STAFF REPORT ACTION REQUIRED

Sign Variance - 1195 Danforth Ave

Date:	January 15, 2010
To:	Toronto and East York Community Council
From:	Director, Toronto Building, Toronto and East York District
Wards:	Ward 30 – Toronto-Danforth
Reference Number:	P:\2010\Cluster B\BLD\Toronto and East York\2010TE024 09 187948 ZSV 00 ZR

Attachment 2: Elevation 1195 Danforth Avenue File # 09_187948 MSTR-IMP-F-050049 Applicant's Submitted Drawing
Not to Scale
01/06/10 RIGHT SIDE ELEVATION - (Illuminated) LEFT SIDE ELEVATION - (illuminated) FRONT ELEVATION - (Illuminated) REAR ELEVATION - (Illuminated) ESSO Elevations The American

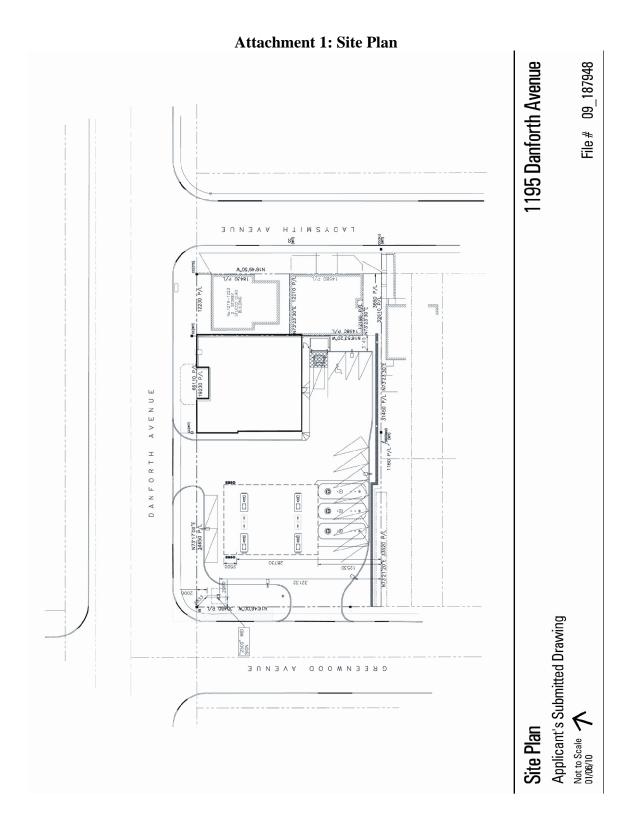
With respect to the first variance, the 2.0 metre set back requirement from the property line and 6.0 metre set back requirement from the intersection of two property lines for a ground sign is aimed at to ensure that commercial streetscapes and view corridors for motorists and pedestrians are preserved and enhanced and sight lines are not impaired. In this case, the sign set backs 2.0m from the property lines and 2.83m from the intersection

of north and west property lines. Although, the sign does not maintain the minimum 6.0m by-law requirement from the intersection of two property lines, in this case, the vertical clearance from grade to the bottom of sign is 2.70m and therefore, it is staff's opinion that the proposed ground sign at this location would not obstruct the sight lines or view corridors for motorists, cyclist and the pedestrians and it would not adversely impact the surrounding uses or the streetscape.

1. Toronto and East York Community
Council approve the requested
variances to permit, for
identification purposes, an
illuminated ground sign on the
northwest corner of the property at
1195 Danforth Avenue and require
